# 1997 Corvette: Service Bulletin: Water Drips into Rear Compartment After Hatch/Glass Has Been Opened

**Subject:** Water Drips into Rear Compartment After Hatch/Glass Has Been Opened (Modify Weatherstrip)

**Number:** 73-10-55

**Models:** 1997 Chevrolet Corvette

**Figure 1 - Sideview**

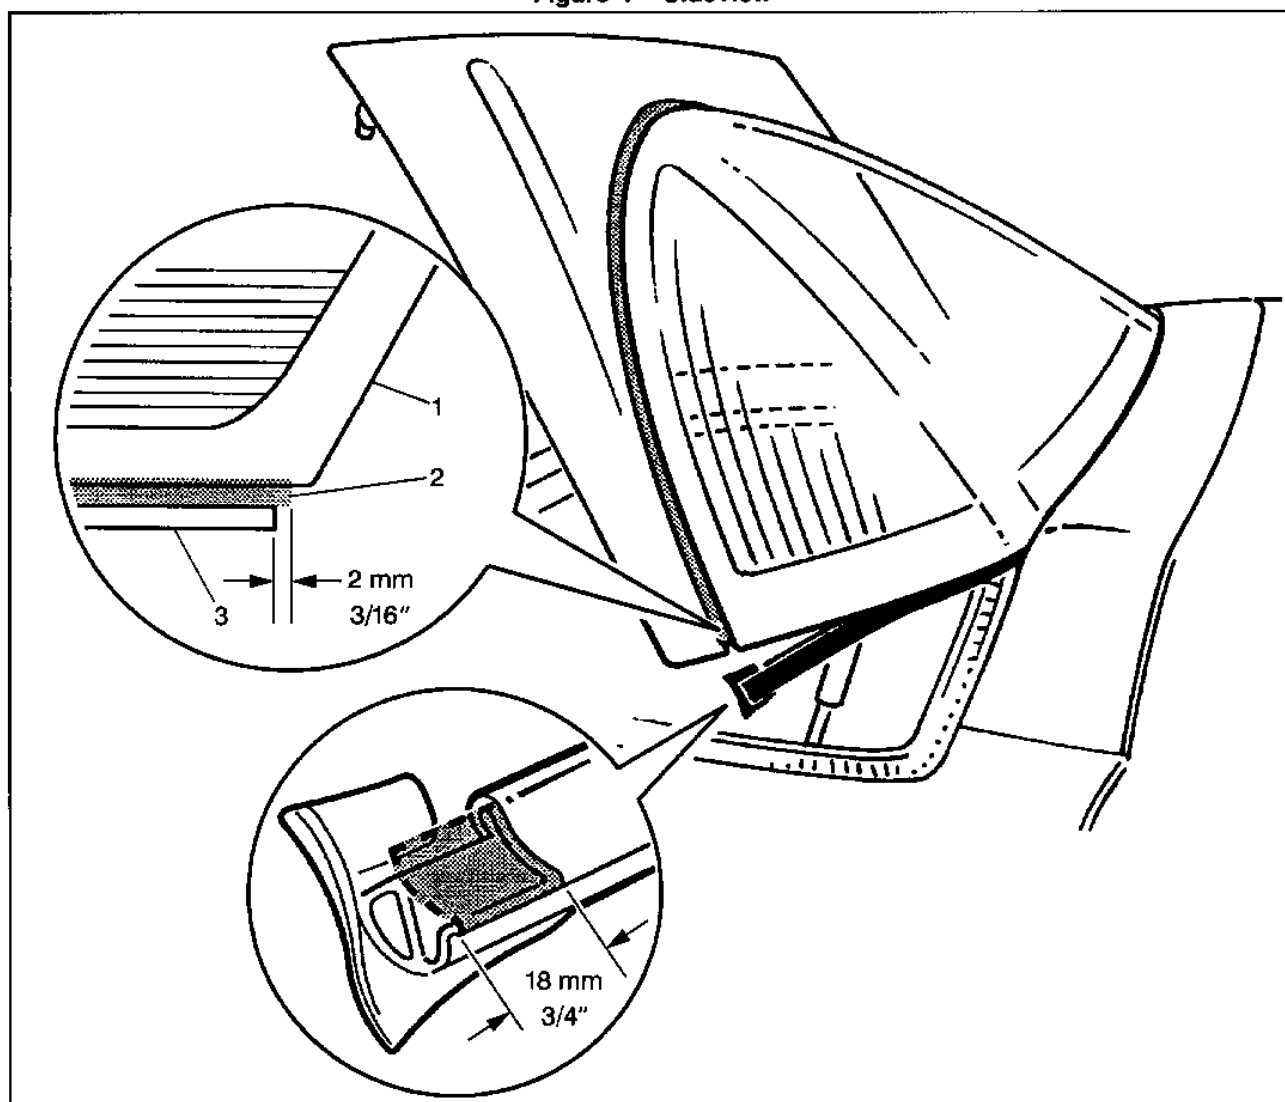
**Condition:** Some owners may comment that water drips into the rear compartment after the hatch glass has been opened.

1. Pull down weatherstrip to gain access to the end of the black close out weatherstrip (see Figure 1, top view). With a utility knife, cut the close out weatherstrip so there is a 2 MM (3/16 in.) overhang of the weatherstrip to its mounting surface (See Figure 1, top view)
2. With weatherstrip pulled down, measure 18 MM (3/4 in.) from end of weatherstrip and remove shaded area from weatherstrip (see Figure 1, bottom view). Reinstall weatherstrip on hatch.
